Addendum No. 4

OMAHA RAPID BUS TRANSIT (ORBT) STATION CANOPY PACKAGE

Project No. NE-79X-001/ Specification No. 25-18

Date Issued: 8/20/2018

SPECIFIED ITEM: Metal Wall Panels /Concealed-Fastener,Lap-Seam Metal Wall Panels

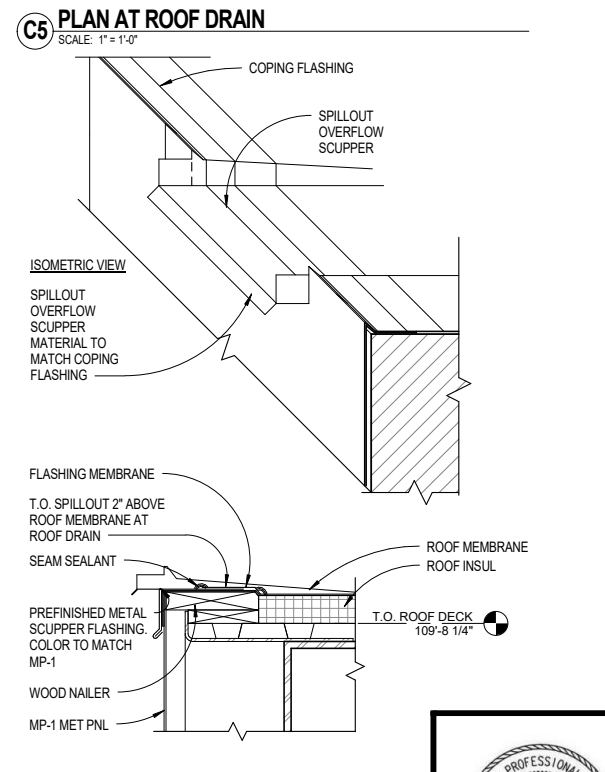
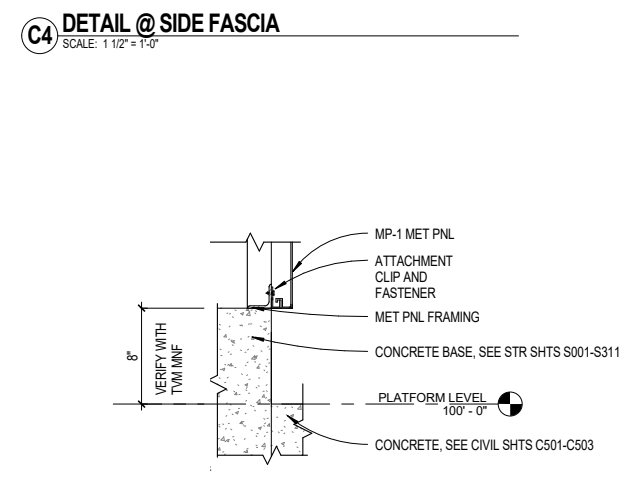
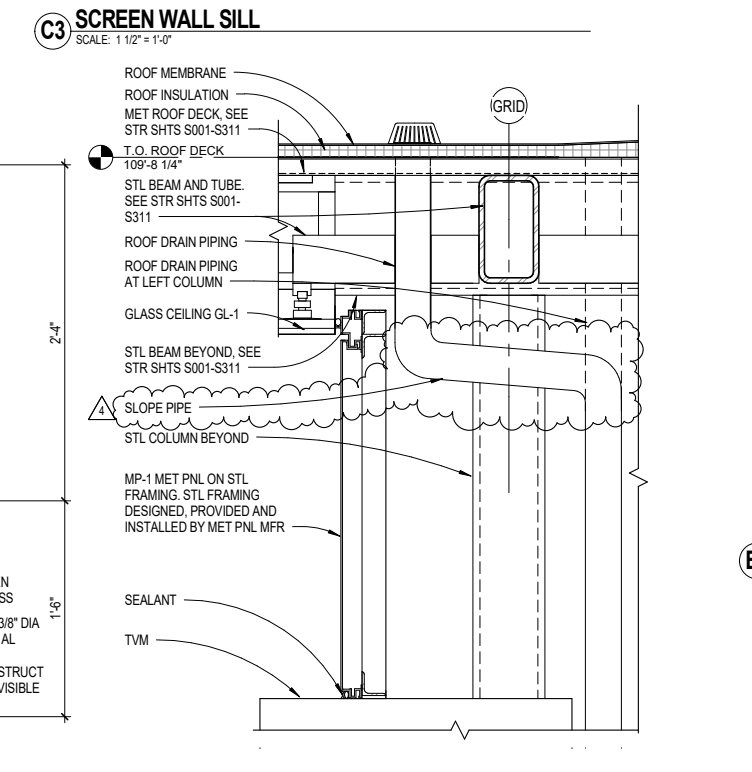
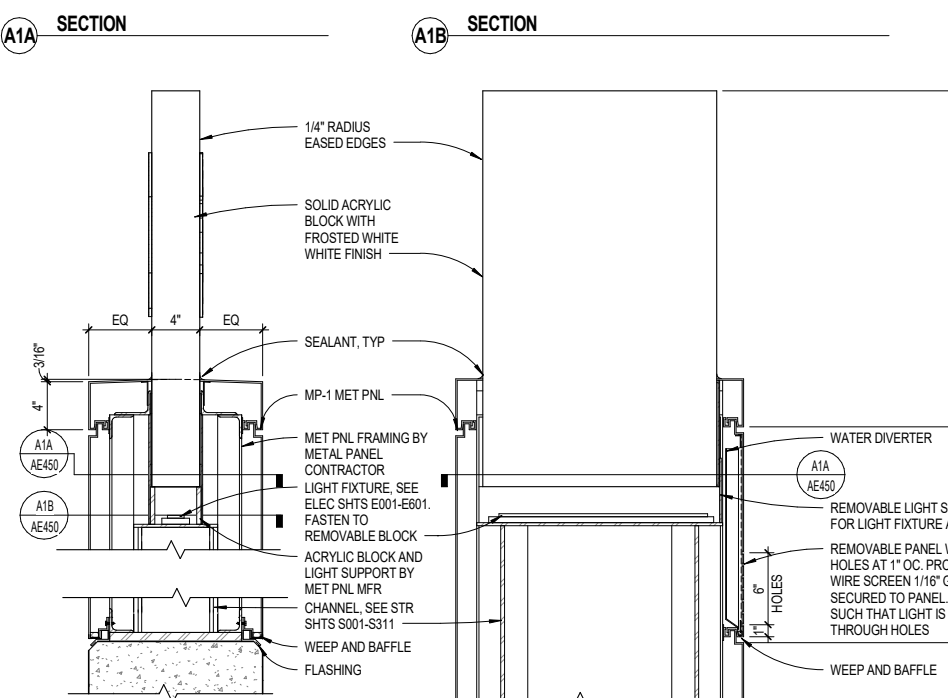
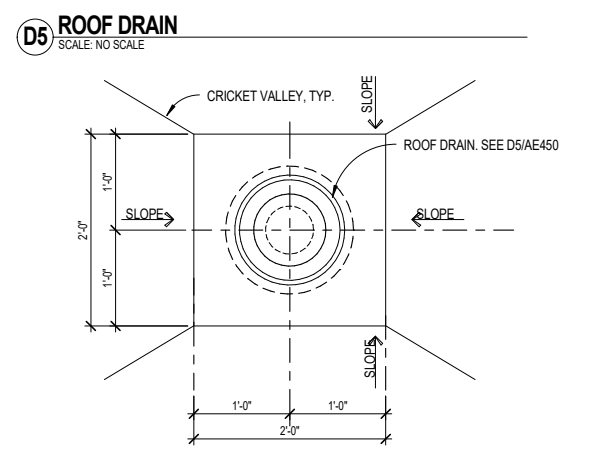
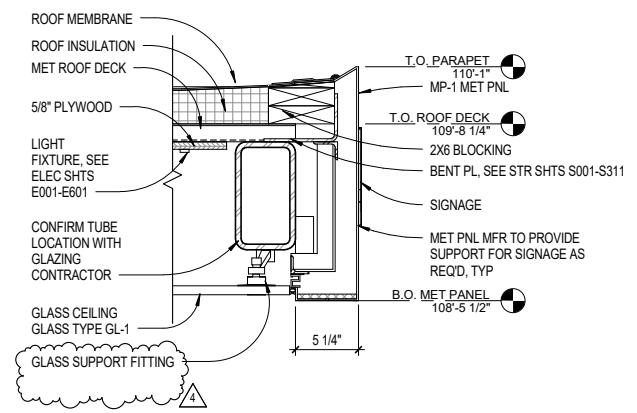
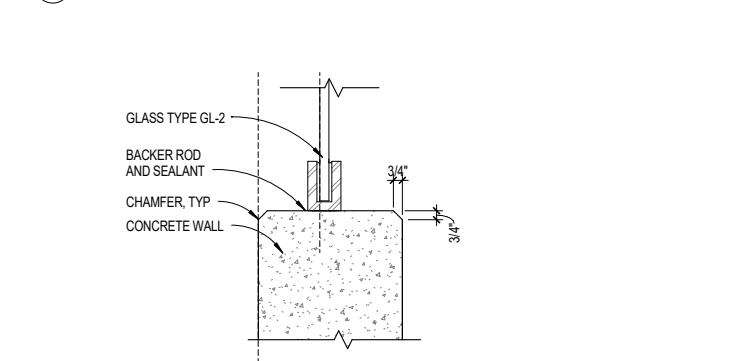
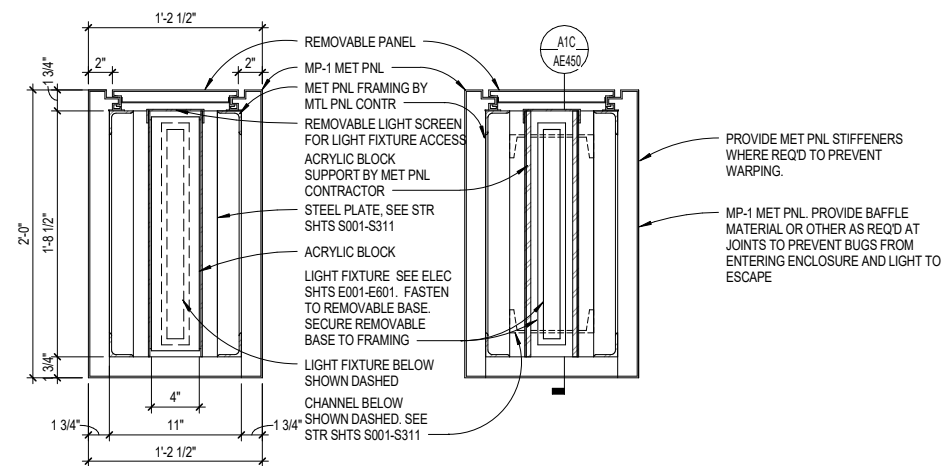
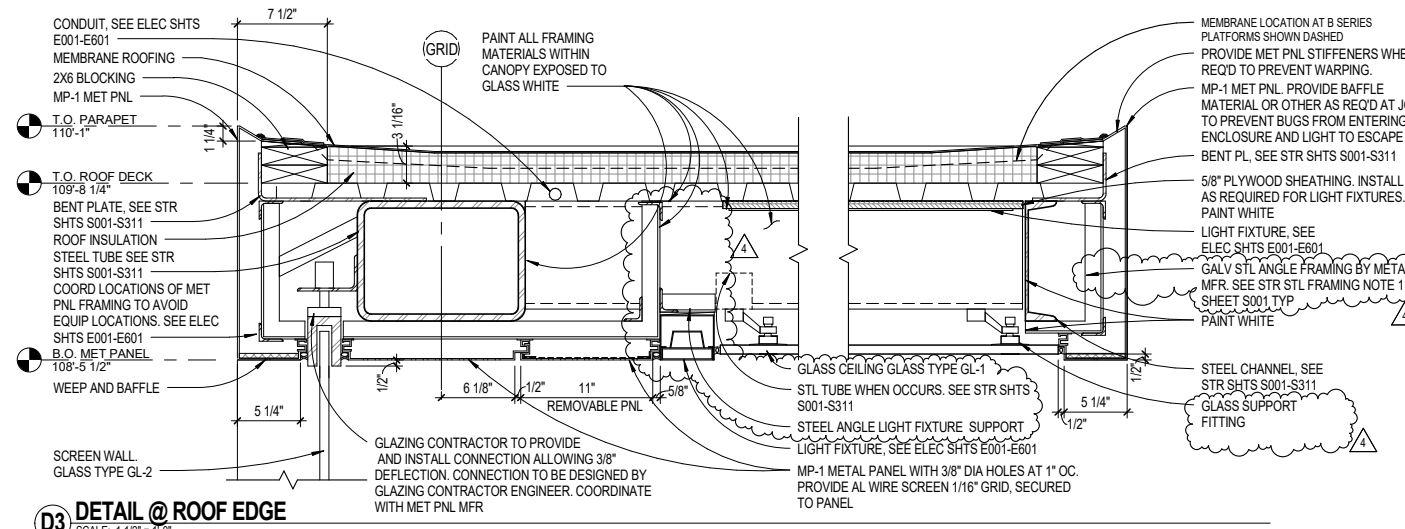
PROPOSED SUBSTITUTION: NorthClad AL Series Dual Interlocking Panels

REASON FOR NOT GIVING PRIORITY TO SPECIFIED ITEMS: NorthClad provides a superior
quality product.

- b) At section 2.3, A., 1. add the following to list of manufacturers: “g. NorthClad”
- c) Delete paragraph 1.6, D. “Fire-Resistance.... testing agency.” in it’s entirety.
